Technical Service Information

THM 4T60-E NEW REVERSE REACTION DRUM FOR 1997 MODELS

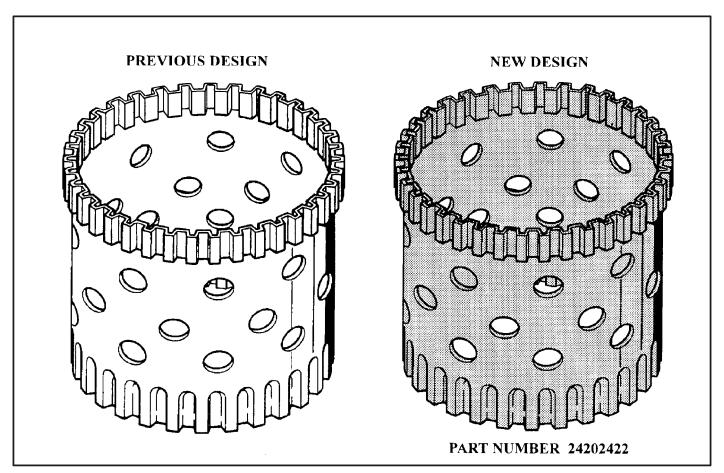
CHANGE: Beginning at the start of Production for 1997 models, all THM 4T60-E transaxles were built

with a new design Reverse Reaction Drum, as shown in Figure

REASON: Greatly increased durability of the Reverse Reaction Drum.

(1) REVERSE REACTION DRUM - New design has been through a hardening process and can be identified by its blackened color, as shown in Figure 1.

The new design Reverse Reaction Drum will retro-fit back on all previous models of the THM 4T60-E transaxles.
